IEEE P802.11
Wireless LANs

LB133: Normative Text Changes for Annex Q**Date:** 2008-SEP-11**Author(s):**

Abstract

Annex Q

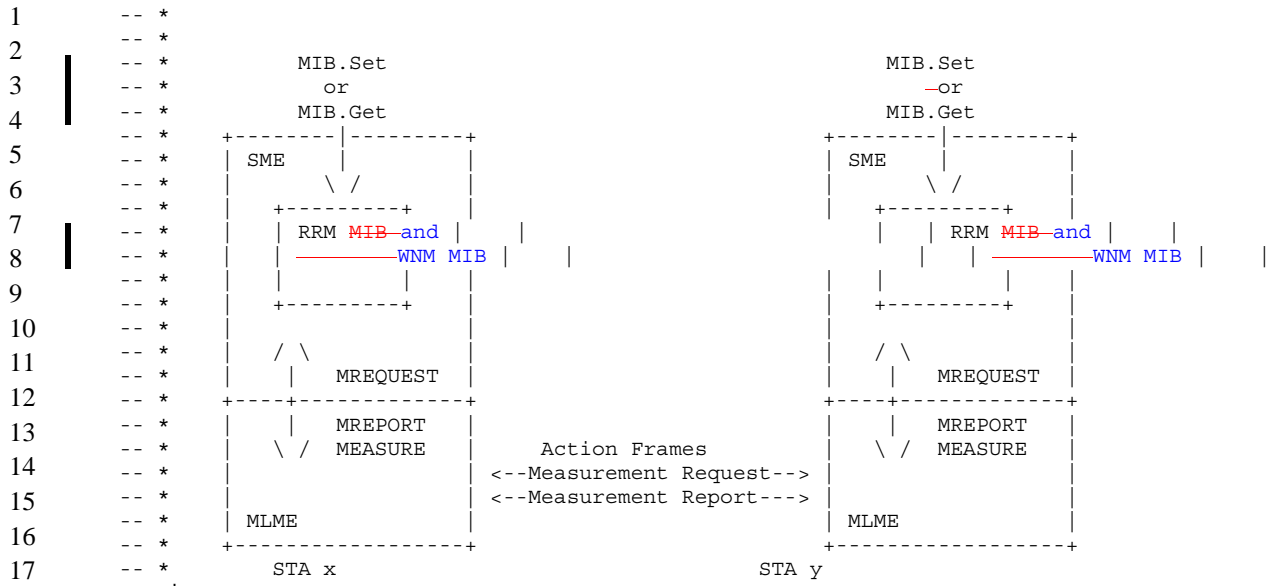
Insert the following new Rename and modify Annex Q as shown:
